Firmware: <http://172.31.25.14/36/test/TelevendC6-1-16-11-b86.bin>

2. ACTIVATE ONLY ONCE (non-repetitive schedule)

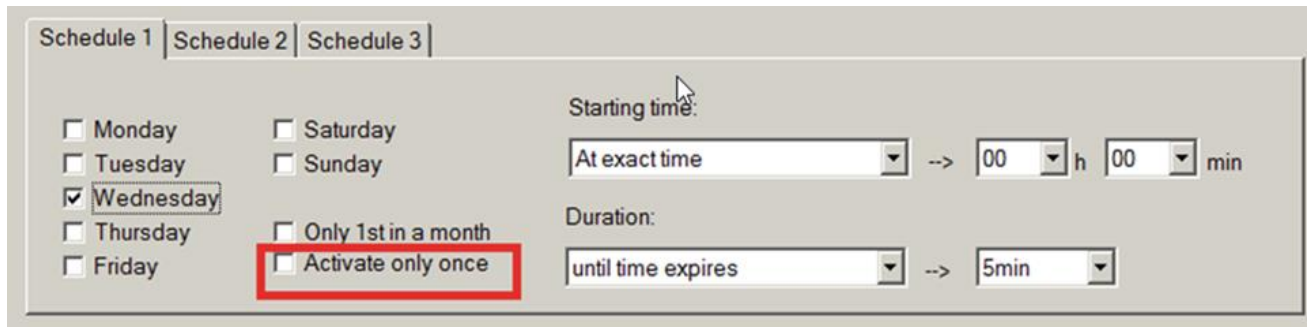
It is possible to declare a schedule as non-repetitive – in this case, Happy hour is executed only once and never again (note: as up to three schedules can be defined, it is possible to define up to three such non-repetitive events in a period of one week).

Limitation: the 'activate only once' checkbox is not available in some cases (e.g., if you define that the schedule is performed for more than one day a week).

5. AUTOMATIC TIME ZONE DETERMINATION

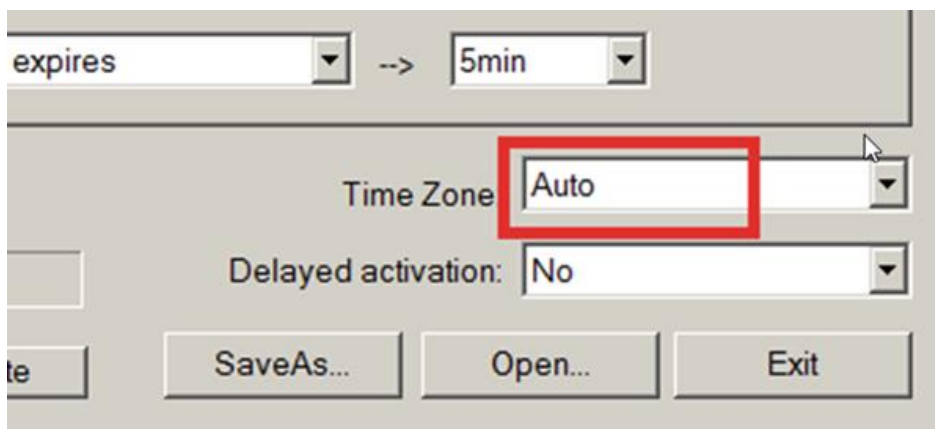
When the "Auto" time zone option is selected, then the Televend box tries to determine the time zone using data from the modem or TZ +/TZ- special handling.

6. R_AUDIT / HAPPY COMMAND SUPPORTED

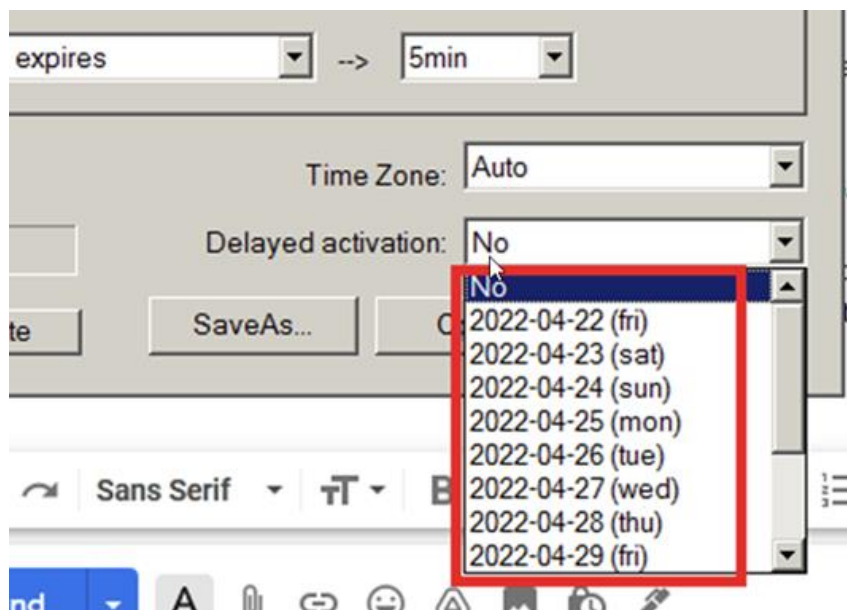
This command can be used to interpret which was the last Happy hour configuration string sent to the Televend box.
